Permit Type Building/Residential/Alteration/SFD Permit Number B24001539 Opened Date 04/28/2024
Description of Work SFD/ ALTERATIONS TO FIRST FLOOR TO INCLUDE CONVERT PART OF A CLOSET TO SHOWER IN FULL BATH APX 70 SQ FT.**SUBJECT TO FIELD INSPECTION**

From: Oswald Jr, Woodin
Sent: Thursday, May 2, 2024 7:58 AM
To: VKBKITCHENANDBATH@GMAIL.COM
Subject: B24001539_3654 Daisy Road

DUMOND RESIDENCE FIRST FLOOR
EXISTING PLAN

DUMOND RESIDENCE FIRST FLOOR
PROPOSED PLAN

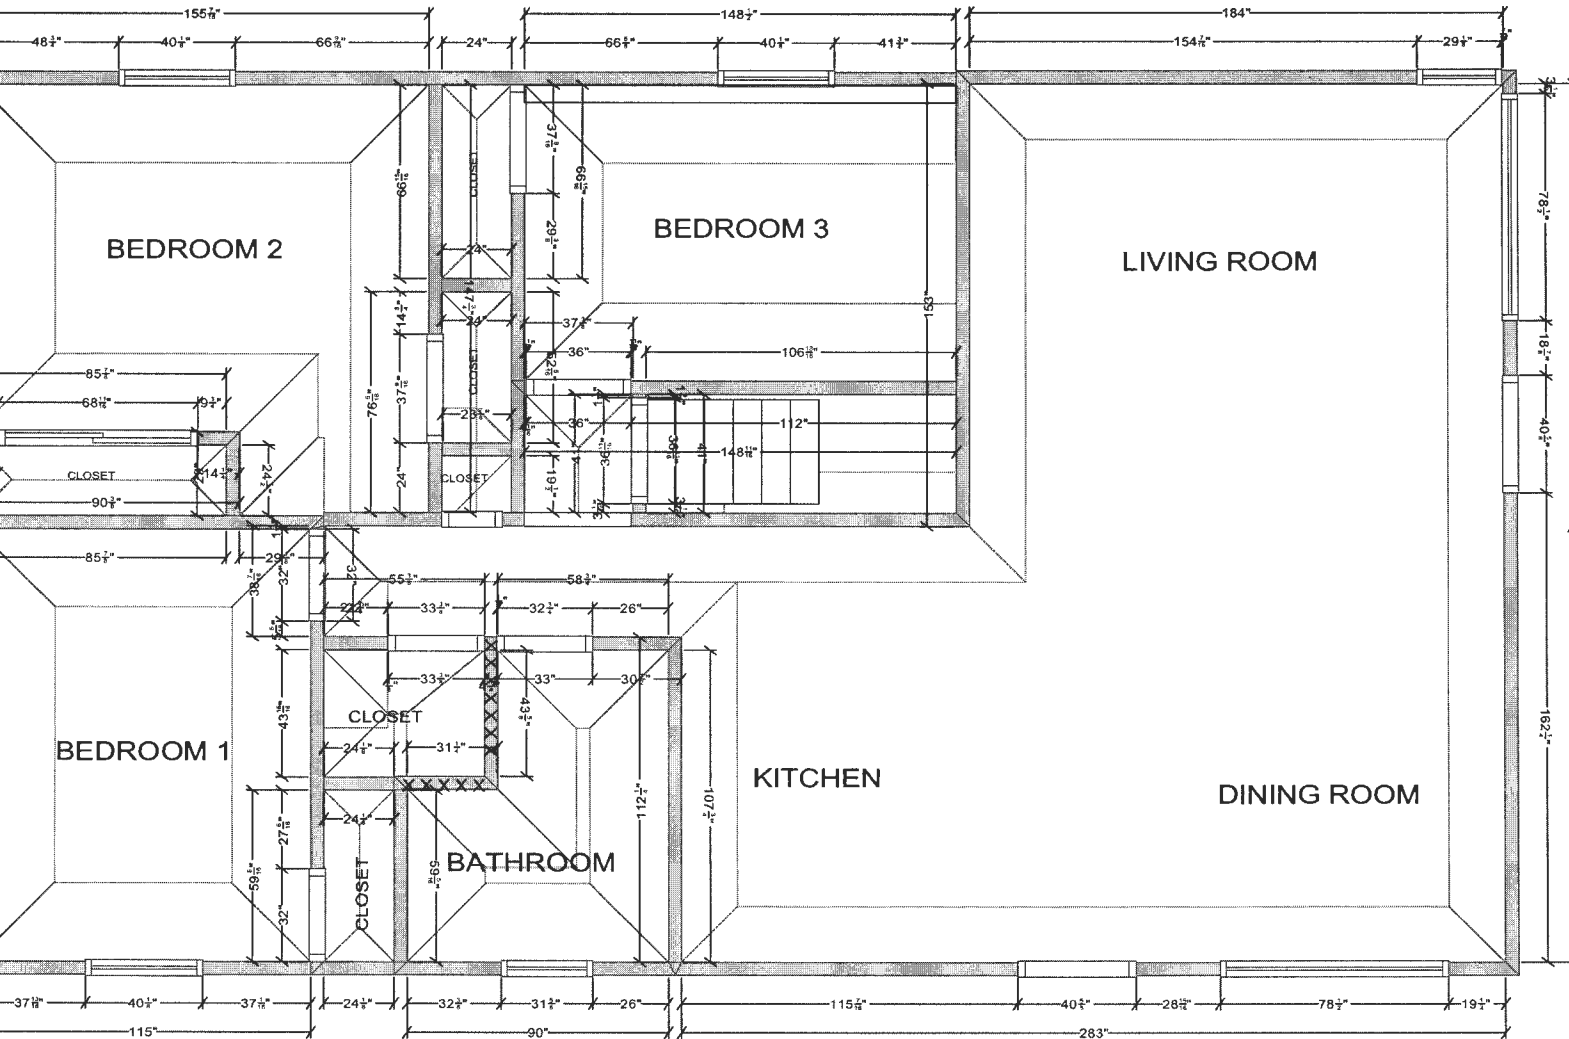
Good morning. I am currently reviewing the building permit for 3654 Daisy Road. At your earliest convenience, please forward a copy of the existing floor plan for the basement/lower level. The floor plan may be hand drawn, but it needs to show all finished and unfinished rooms, half/full bathrooms and doors and windows.

This is follow-up to our telephone conversation this morning (5/28/24). The existing floor plan shows 4 bedrooms (3 on main floor, and 1 in the basement), but the septic system was designed for just 3 bedrooms. To receive building permit approval by this office, you have two options:

1. Modify a bedroom, so that it no longer meets the definition of a bedroom (see attached definition), **OR**
2. Conduct perc test to establish a sewage disposal area on a percolation certification plan, and make upgrades to the existing septic system. Upgrades will include installing a larger septic tank and possibly new trenches.

If you wish to modify a bedroom, a revised floor plan must be submitted to the permits office showing one of the following modifications to an existing bedroom.

1. Remove the door and case the opening into the room to be 4 foot wide, or
2. Install permanent built in book case units, desk and other features around the majority of the room, or
3. Install half wall between existing bedroom and another room.
